Service Bulletin No: 57-011

**WINGS - OUTER WING
INSPECTION OF THE LEFT AND RIGHT OUTBOARD AILERON BEARING-BRACKETS****1. Planning Information****A. Effectivity**

Inspection to Find the Type of Material
Figure 1

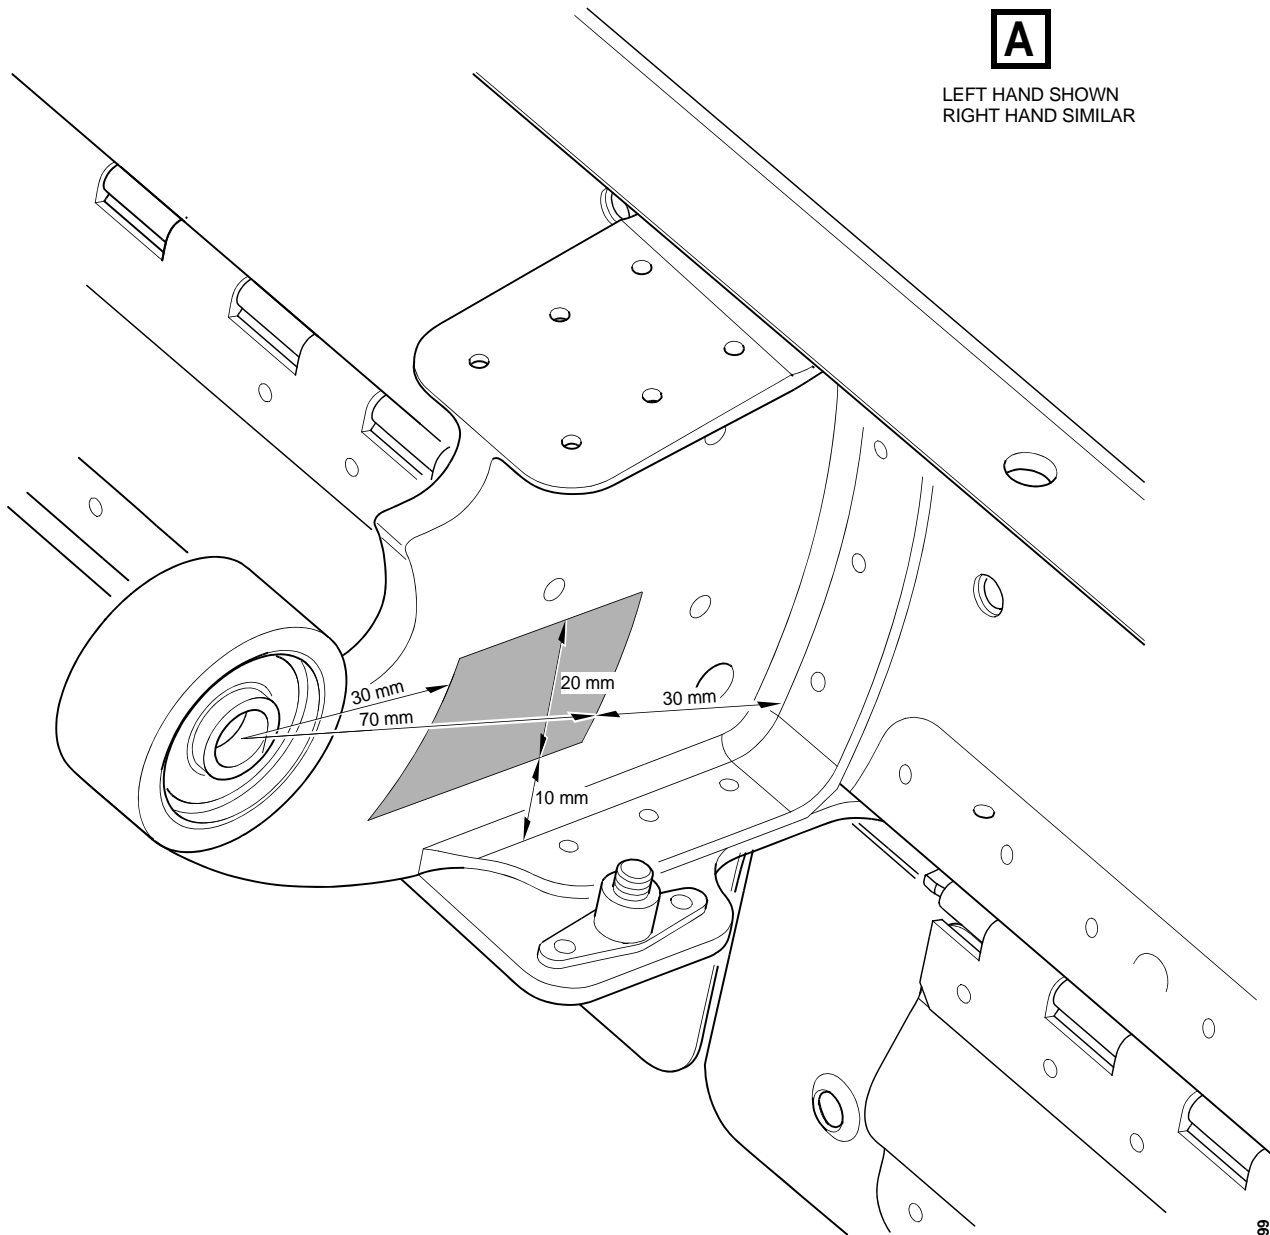
- (1) Obey the manufacturer's operating instructions and calibrate the eddy-current conductivity measurement equipment.
- (2) For the left-aileron outboard bearing-bracket, P/N 557.22.09.281 (Ref. Fig. 1):
 - (a) Remove the dirt and grease from the test area with the absorbent paper (Material No. P02-031) made moist with the solvent (Material No. P01-010).

- 1 Put the eddy current probe in position in the test area (shown shaded in the Fig 1).
- 2 Record the value shown on the test equipment.
- 3 Put the eddy current probe on:
 - The AA2024-T351 test piece (P/N 513.57.09.149) and record the value
 - The AA2124-T851 test piece (P/N 513.57.09.150) and record the value.
- 4 Do a comparison of the values recorded on the eddy-current conductivity measurement-equipment for:
 - The left bracket assembly (P/N 557.22.09.279)
 - The AA2024-T351 test piece (P/N 513.57.09.149)
 - The AA2124-T851 test piece (P/N 513.57.09.150).

- 5 If the value for the left bracket assembly (P/N 557.22.09.279) is similar to the value recorded for the AA2024-T351 test piece (P/N 513.57.09.149):

- 6 If the value for the left bracket assembly (P/N 557.22.09.279) is similar to the value recorded for the AA2124-T851 test piece (P/N 513.57.09.150):

Inspection to find Cracks
Figure 2

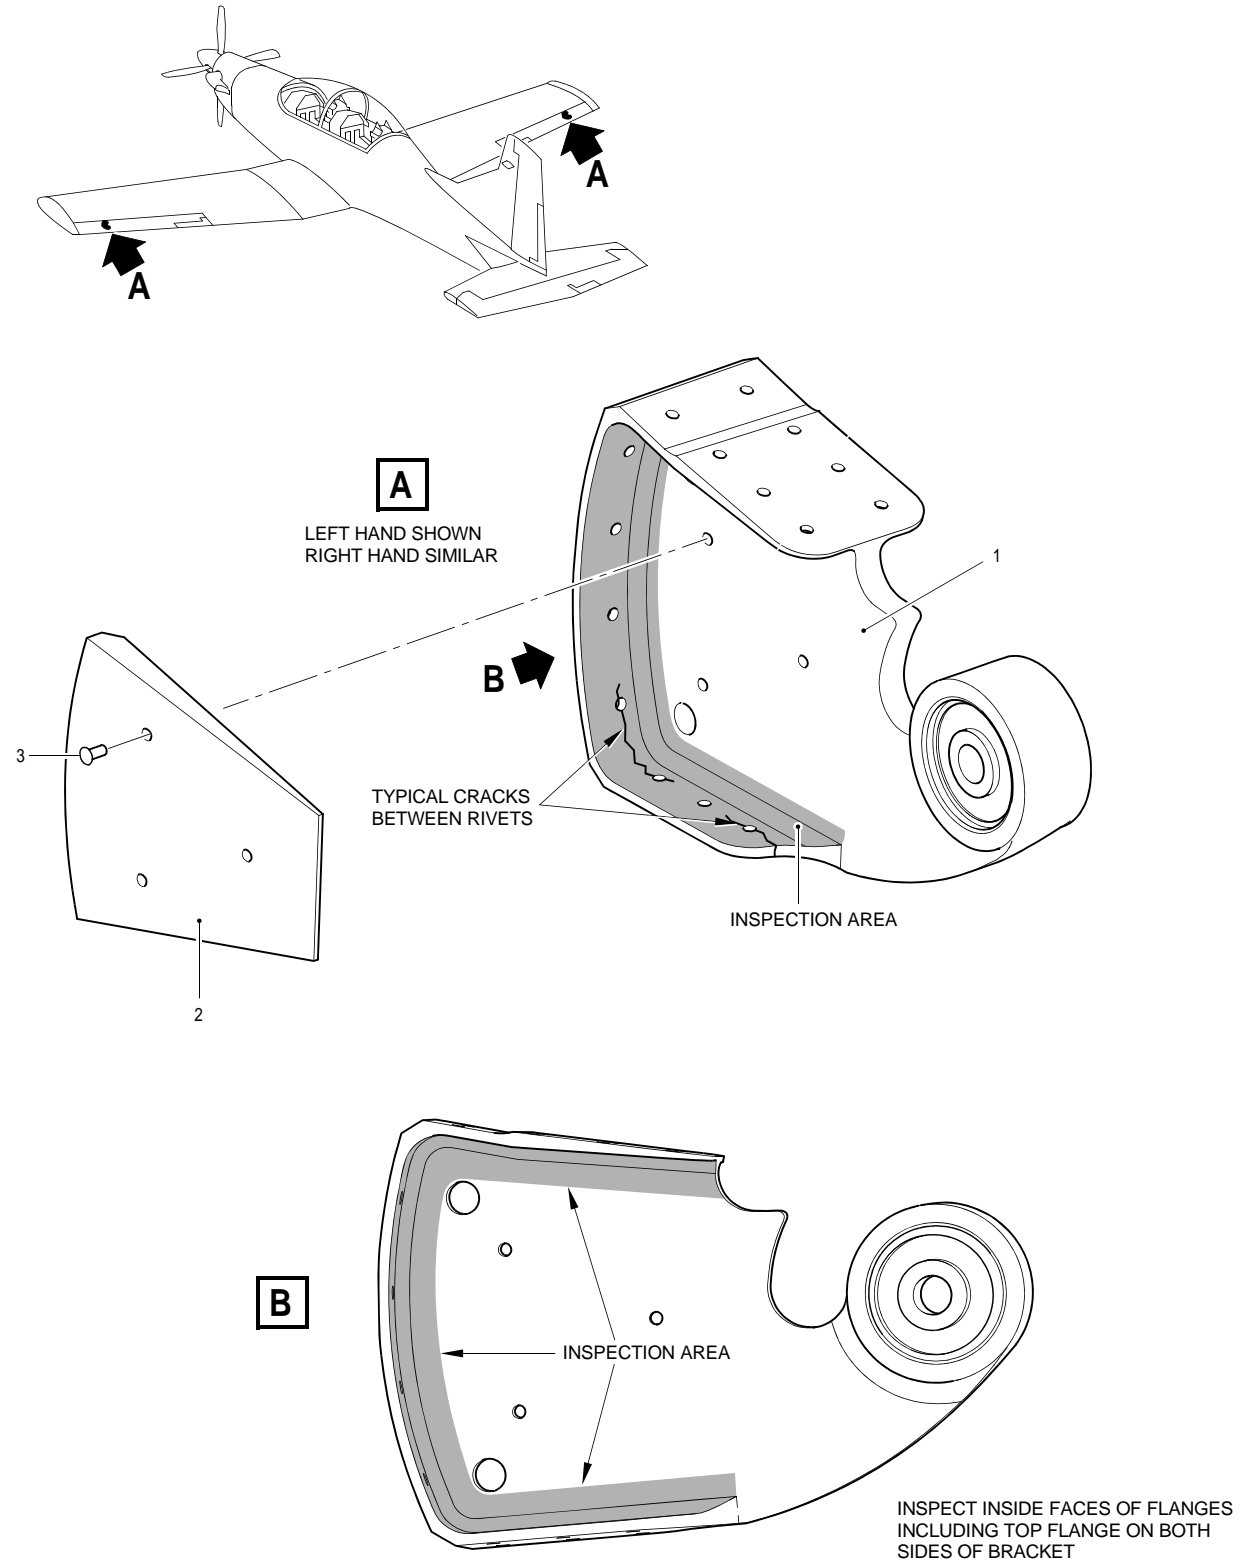
C. Do an Eddy-Current Crack-Detection Test (Ref. Fig. 2)

- (1) Remove the applicable aileron (Ref. AMM, 27-10-01, Page Block 401).
- (2) Use the applicable sized drill and remove the three rivets (3) that attach the shim (2) to the applicable aileron outboard bearing-bracket (1).
- (3) Remove the dirt and grease from the test area with the absorbent paper (Material No. P02-031) made moist with the solvent (Material No. P01-010).

- (4) Obey the manufacturer's operating instructions and calibrate the eddy-current crack-detection equipment.
- (5) Move the probe of the eddy-current crack-detection equipment over the areas shown in Fig. 2.
- (6) If you find cracks:
 - Continue with this Service Bulletin from Step 3.C(12)
 - Do Service Bulletin 57-012 before the next flight.

- (7) Remove the dirt and grease from the shim (2) with the absorbent paper (Material No. P02-031) made moist with the solvent (Material No. P01-010).
- (8) Put the shim (2) in position and hold with gripper pins or equivalent.

- (9) Install the three rivets (3) (P/N MS20426AD3 or NAS1097AD3) with a countersunk on both sides of the joint.
